IMPORTANT SAFETY RECALL 22V-674

SN712

MODELS AFFECTED: TL80, TL80/112, TL100

SUBJECT: Boom Tip Leveling Cylinder Support Boss Weld

Figure 1. Welds to Inspect, Both Sides of Leveling Cylinder

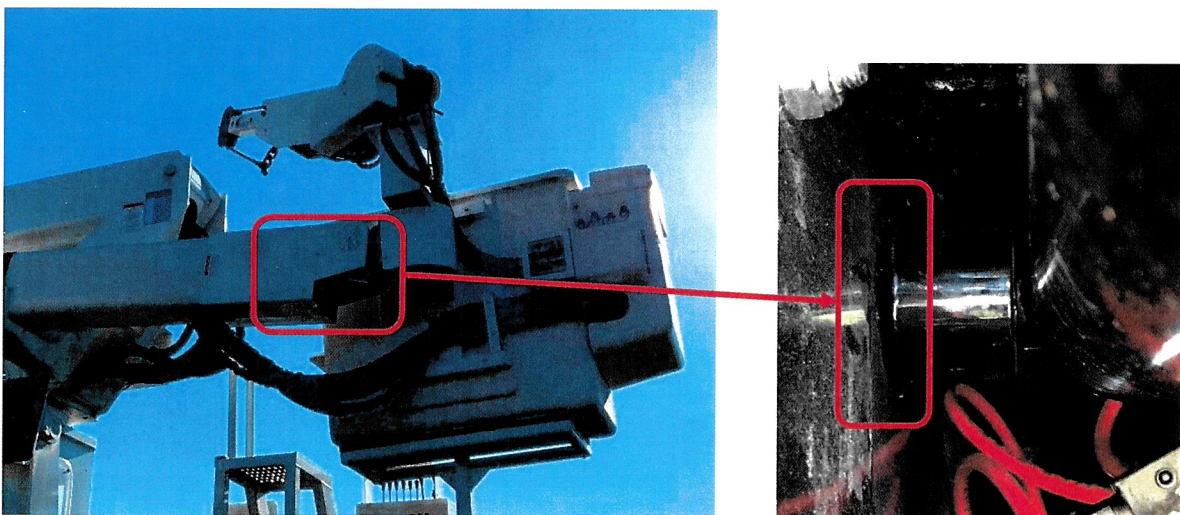
Terex model TL80, TL80/112, and TL100 aerial devices, produced from March 2019 through August 2022, may have the welds for the boom tip leveling cylinder support boss fail. Once the welds fail, the cylinder base pin may flex repeatedly until it cracks, and it may fail. **Failure of the cylinder base pin may result in the platform tipping, causing the platform occupants to fall resulting in injury.**

1. Immediately inform all users, operators, and supervisors of the content of this bulletin.
2. Inspect for cracks of the boom tip leveling cylinder boss to boom welds, using Figure 1 as reference.
 - a. If the welds are not cracked, see the Continued Use section in this bulletin.
 - b. If the welds are cracked, do not use the machine until Field Service Kits Z1665 and Z1666 (TL80/112 only) are installed.

1. Visually inspect the boom tip leveling cylinder boss welds daily before use until Field Service Kits Z1665 and Z1666 (TL80/112 only) are installed.
 - a. If the welds are not cracked, machine use can continue until Field Service Kits Z1665 and Z1666 (TL80/112 only) are installed.

- b. If the welds are cracked, do not use machine until Field Service Kits Z1665 and Z1666 (TL80/112 only) are installed.
2. Contact Terex Utilities using the contact information in this bulletin to arrange repair using the following guidelines:

Terex will provide for all TL80, TL80/112, and TL100 machines Field Service Kit Z1665, parts and six (6) hours labor, at no cost to the customer. Field Service Kit Z1665 will add reinforcement plates to the boom tip leveling cylinder bosses inside the upper boom. For all TL80/112 machines, Terex will also provide Field Service Kit Z1666, parts and two (2) hours labor, at no cost to the customer. Field Service Kit Z1666 will add a ratcheting tie down for the hydraulic elevator at the base of the machine.
